MISSION BAY SUBSEQUENT ENVIRONMENTAL IMPACT REPORT

PLANNING DEPARTMENT FILE NO. 96.771E

VOLUME III: SUMMARY OF COMMENTS AND RESPONSES

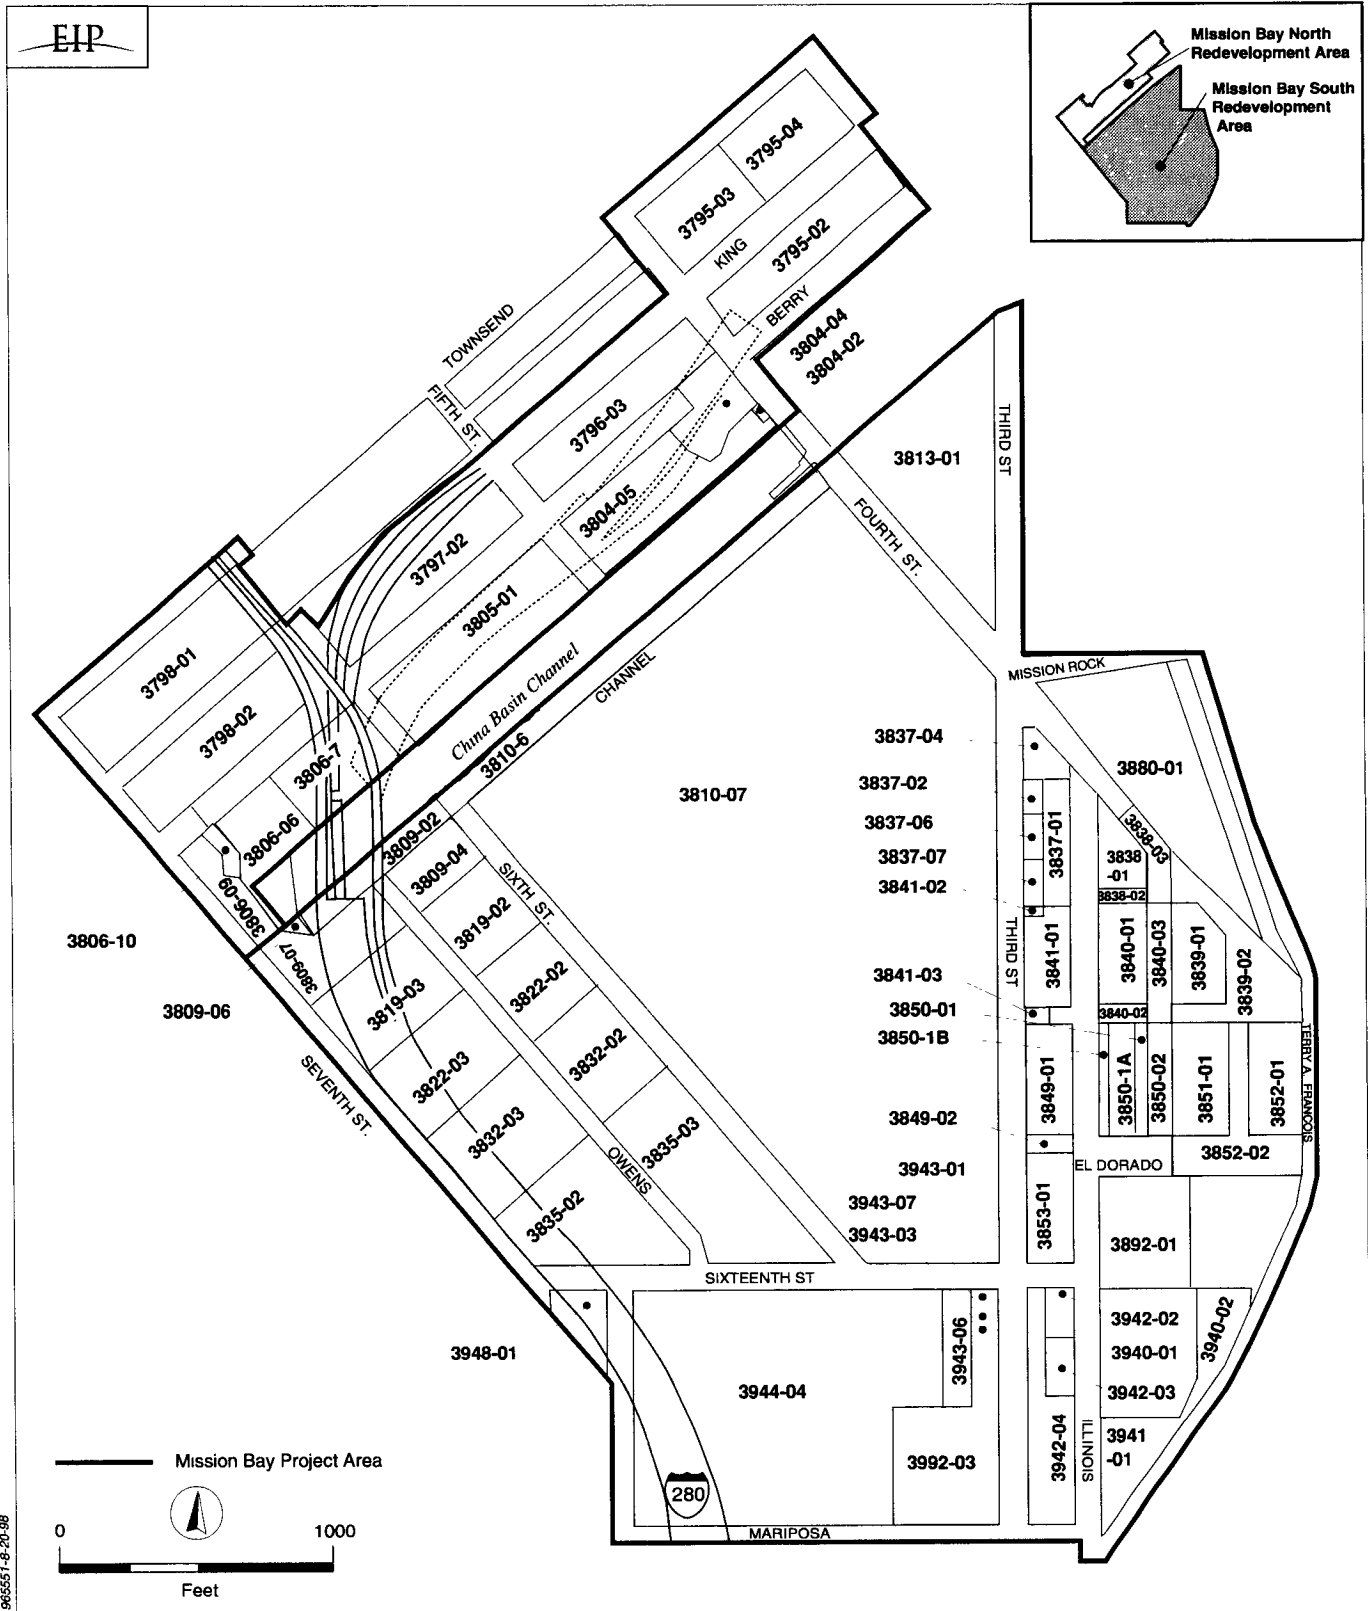
Many of the figures in the DEIR show the existing Caltrain right-of-way as some use other than railroad. No portion of the Caltrain right-of-way has been vacated or abandoned (Figure V.B.2). The figures should be clarified to show that Caltrain intends to continue occupying all of the property for the purpose of operating train service indefinitely. Caltrain is now in the process of developing plans to reconfigure and improve its track, signals, buildings and other facilities at its 4th and Townsend Street terminal. (*Darrell J. Maxey, P.E., Chief Engineer, Caltrain*)

As the comments suggest, Caltrain controls the right-of-way along Seventh Street; however, the underlying title is held by Catellus, as shown in Figure III.B.2. The Caltrain right-of-way is appropriately designated public facilities in Figure III.B.3, which shows the Land Use program. Figure V.B.2 shows parking and open land area over the active tracks since they are in use during the day. As noted in the response in Land Use, "Active Freight Rail Lines" on p. XII.51, Figure V.B.2 is amended to designate the active rail freight lines.

**FIGURE VI.2 (REVISED) WEEKDAY P.M. PEAK HOUR LEVELS OF SERVICE:
YEAR 2015 CUMULATIVE, MITIGATED**

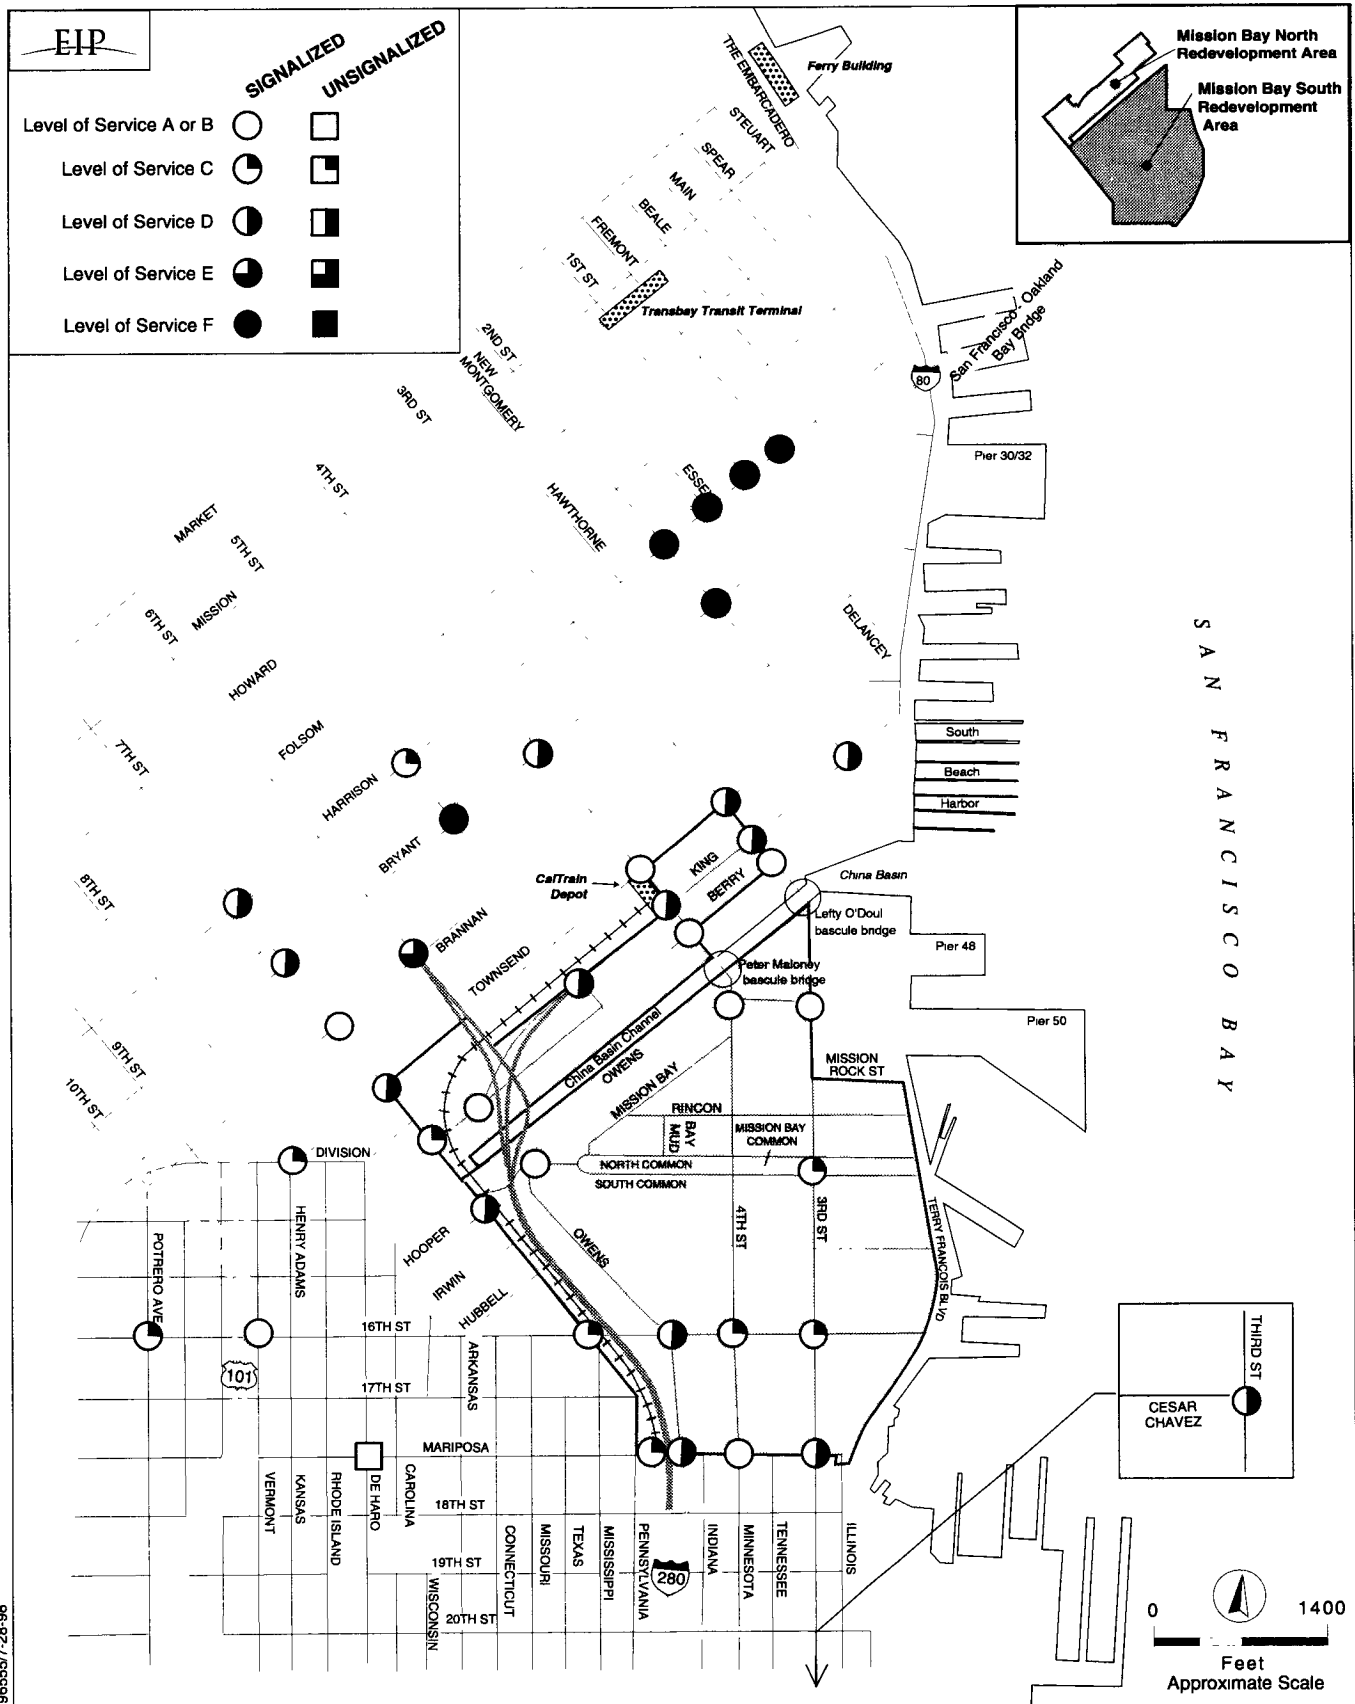
Figure VI.2: LOS indications for the Fourth/King and Fourth/Brannan intersections are not shown (but are present in the corresponding Figure VI.1). Also, figure VI.2 (project cumulative) shows the King/Berry intersection at LOS "C" when it was already at level "D" in Figure VI.1 (existing plus project). This cannot be correct. (*Richard Mlynarik*)

A level of service (LOS) for the intersection of Fourth and Brannan Streets was shown in error on Figure VI.1. This intersection is not a study intersection, and the figure has been corrected to eliminate the LOS marker for this intersection. The LOS marker for the intersection of Fourth and King Streets was inadvertently not shown on Figure VI.2. The intersection of Fourth and King Streets is expected to operate at LOS D under cumulative mitigated conditions. Figure VI.2 has been corrected to indicate this. Both corrected figures are shown on pp. XII.169 and XII.170.

The level of service for the intersection of King and Berry Streets is shown as operating at LOS B under both Existing With Project Mitigated conditions and Year 2015 Cumulative Mitigated conditions. The comment is most likely referring to the intersection of Berry and Seventh Streets, that is shown to operate at LOS D under Existing With Project Mitigated conditions, and to operate as LOS C under Year 2015 cumulative mitigated conditions. These LOS calculations are correct. Under the Existing-With-Project conditions, the intersection would operate at LOS D, and therefore would not require a mitigation measure. However, after adding cumulative traffic growth to the intersection, the operation of the intersection would degrade to LOS F (see p. V.E.69), therefore requiring mitigation. The application of the mitigation measure described in Table VI.5 on p. VI.22 would improve the operation of the intersection to LOS C; therefore, Figure VI.2 is correct in showing the Berry and Seventh Streets intersection at LOS C.
